HIGHWAY WORK PROPOSAL

Proposal Number: **002**

<u>COUNTY</u>	<u>STATE PROJECT</u>	<u>FEDERAL</u>	<u>PROJECT DESCRIPTION</u>	<u>HIGHWAY</u>
Juneau	1016-05-64	N/A	Mauston - Wisconsin Dells; 24th Avenue Structure B-29-24	IH 090
Juneau	1016-05-66	N/A	Mauston - Wisconsin Dells; Koval Rd Bridges B-29-21 & B-29-22	IH 090

Addendum No. 01
ID 1016-05-66
Revised Sheet 38
March 2, 2022

GENERAL PLAN
 SHEET 1 OF 10
38

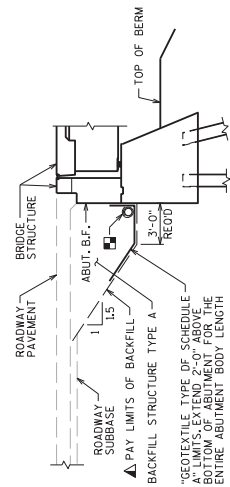
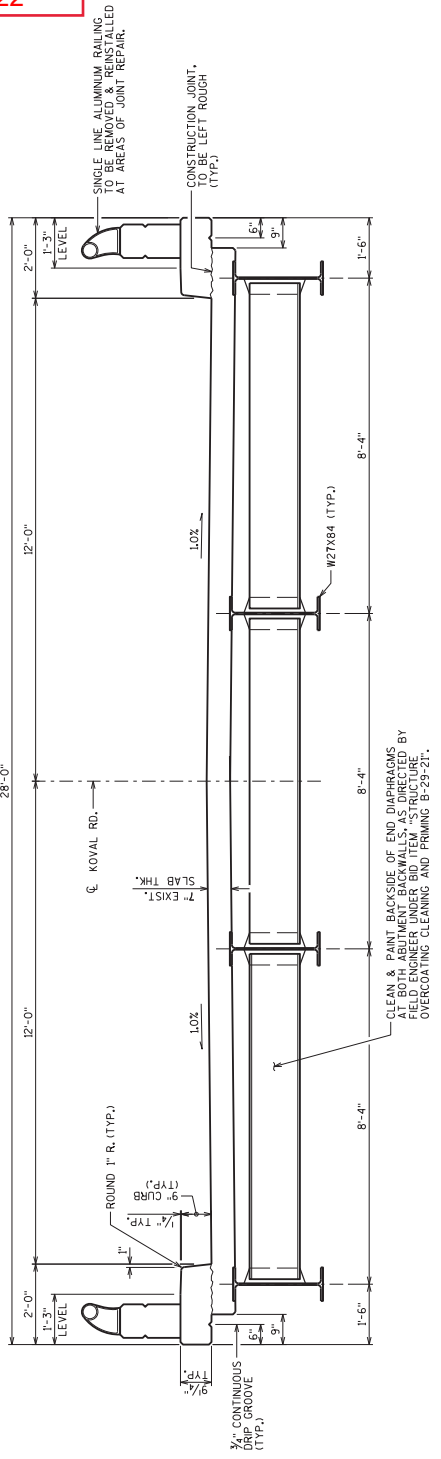
Revised Plan Sheets – 1016-05-66	
Plan Sheet	Plan Sheet Title (brief description of changes to sheet)
38-39	Added Removing Structure Item
48-49	Added Removing Structure Item

NO.	DATE	REVISION
3/22		REVISE GEN. NOTES & BID ITEMS

Added Bid Item Quantities					
Bid Item	Item Description	Unit	Old Quantity	Revised Quantity	Proposal Total
203.0220	Removing Structure 01. B-29-21	Each	0	1	1
203.0220	Removing Structure 02. B-29-22	Each	0	1	1

GENERAL PLAN

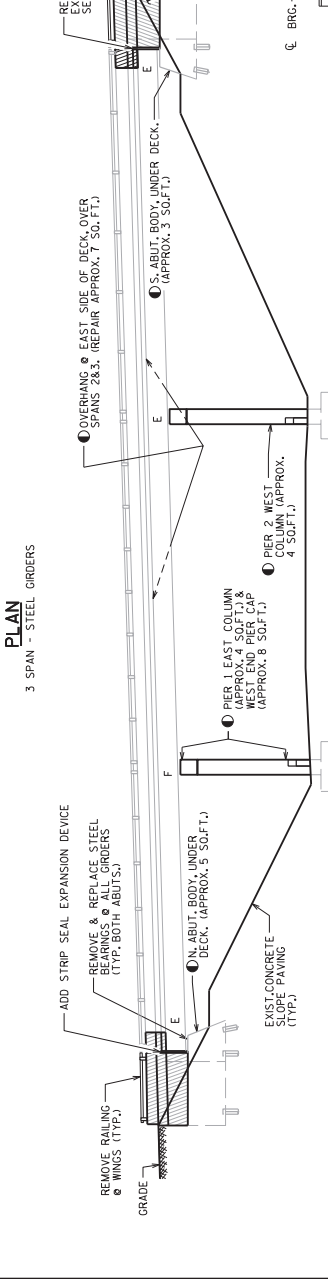
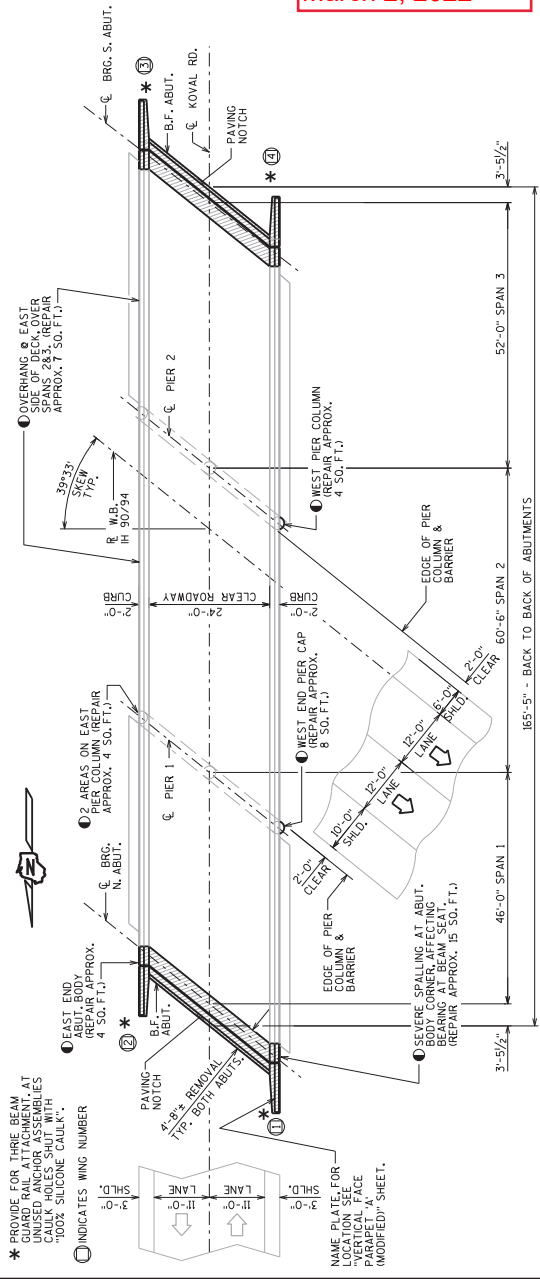
NO.	DATE	REVISION	BY
3/22		REVISE GEN. NOTES & BID ITEMS	ARC
